ADDENDUM '02'

Project Name Collingwood Green Phase 3
Toledo, Ohio

Addendum Date: February 13, 2017

F wall section
A615 $\frac{3}{4}''=1'-0''$

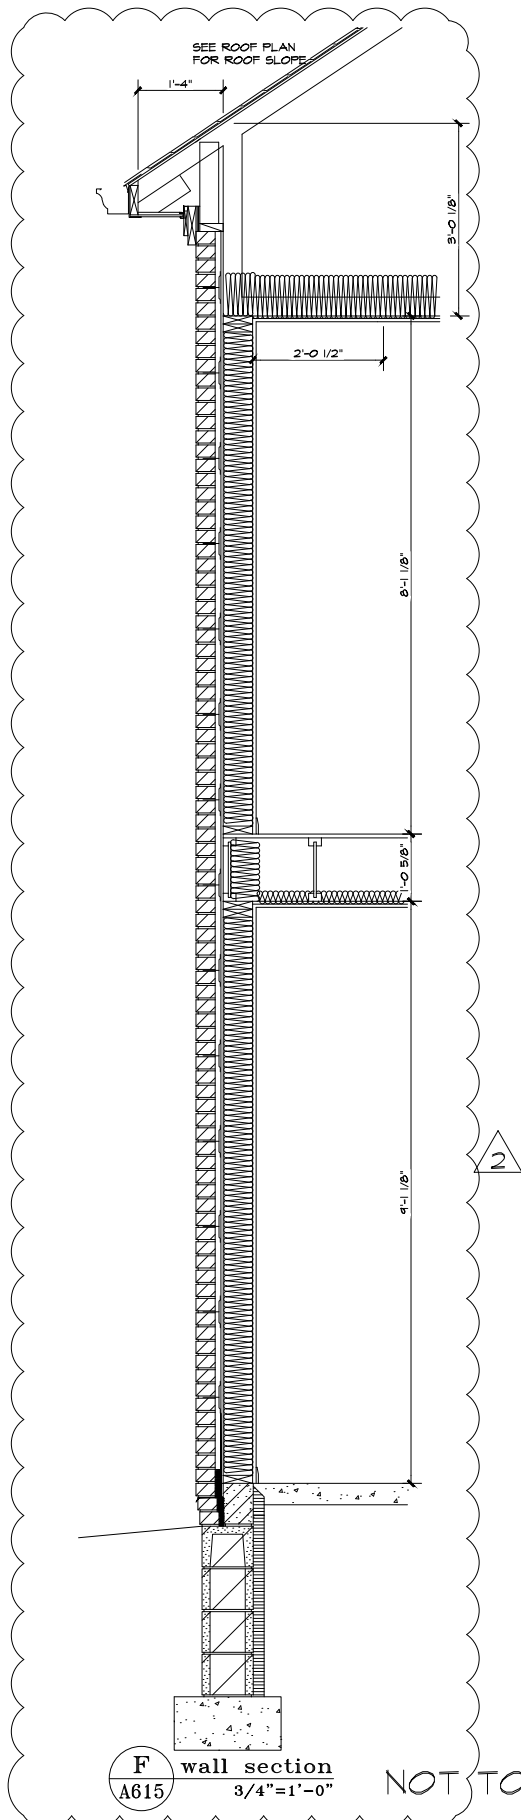
- 31. Sheet A615
 - a. Revise roof framing on sections B and E/A615
 - b. Add new section F/A615. See attached sketches.
- 32. Sheets A619 – A622:
 - a. New Wall Section Sheets added for clarification; See attached sheets.

2 unit "C" 3br townhouse
 first floor plan
 3/16" = 1'-0"

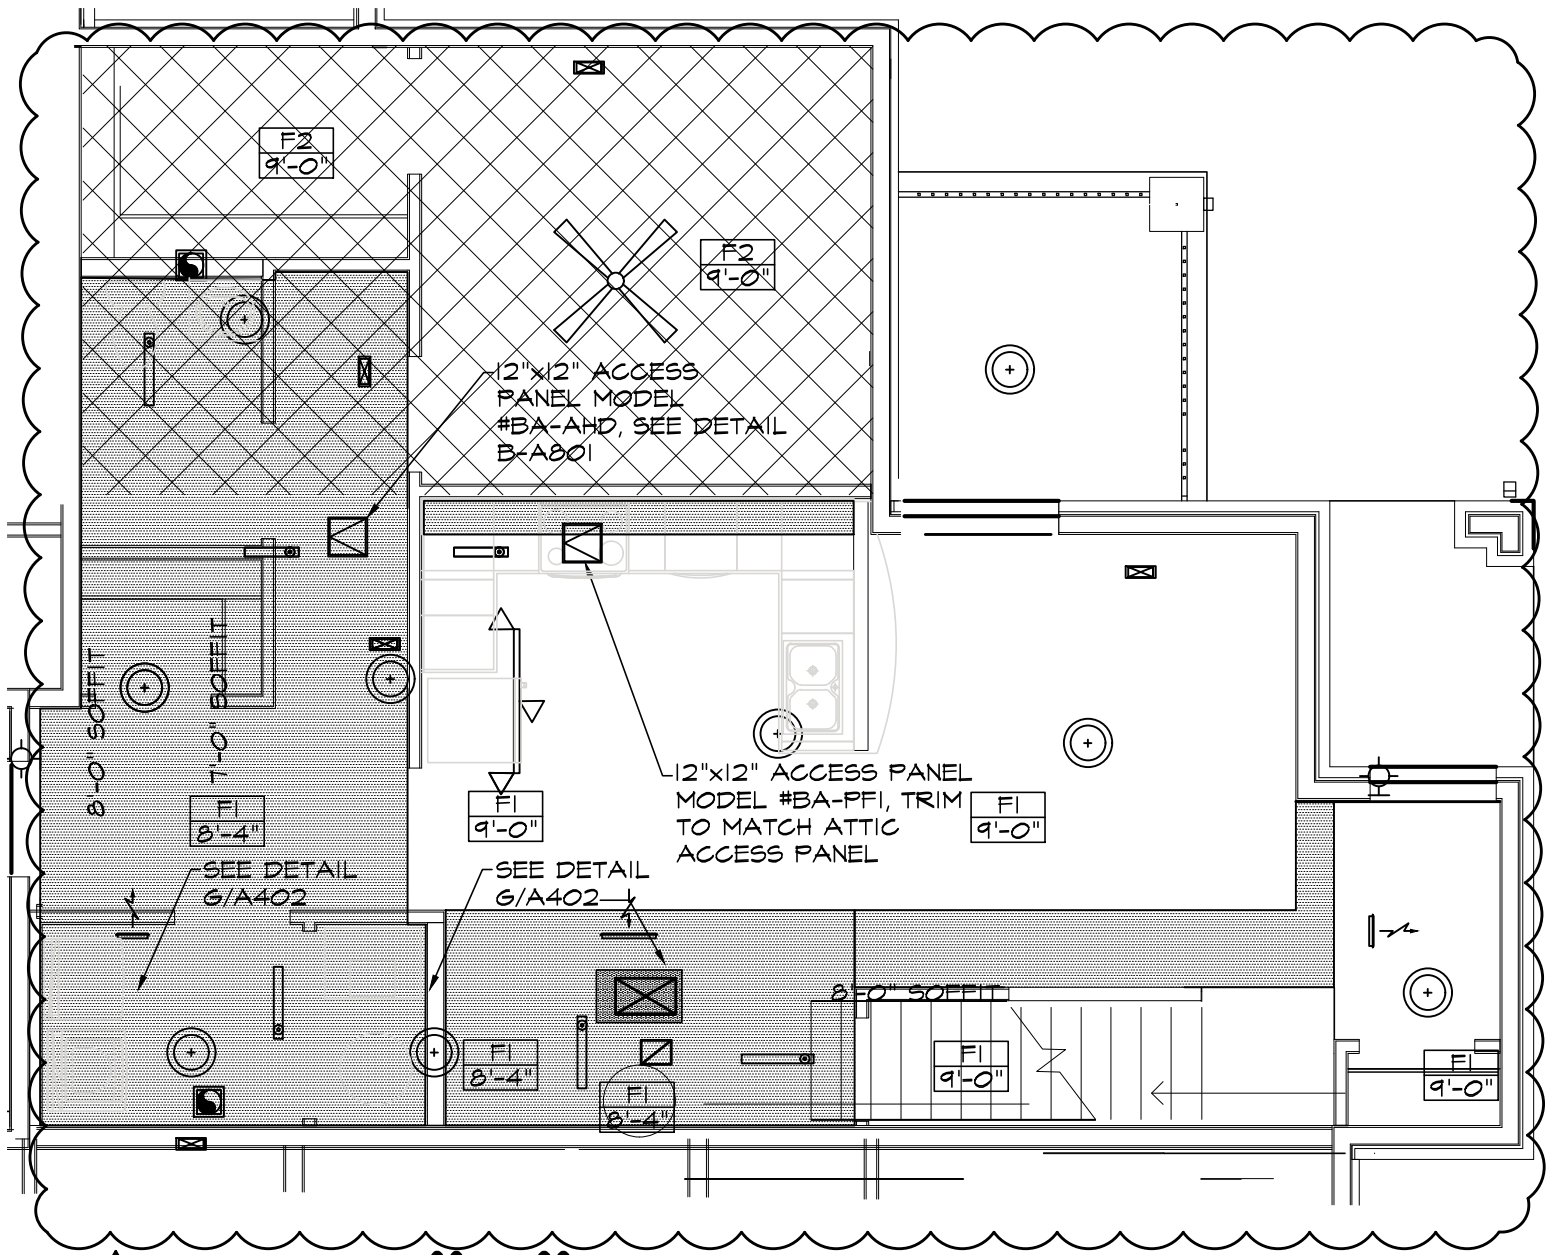
- 33. Sheet A701
 - a. Removed Tyvek proprietary window flashing detail from sheet.
- 34. Sheet A801; see attached sketches
 - a. Updated floor plan for Unit ‘C’ 3br townhouse first floor plan. Added motor operated damper access panel and added the following coded note: MECHANICAL DAMPER ACCESS PANEL – CONTRACTOR TO COORDINATE ACCESS PANEL SIZE AND LOCATION.
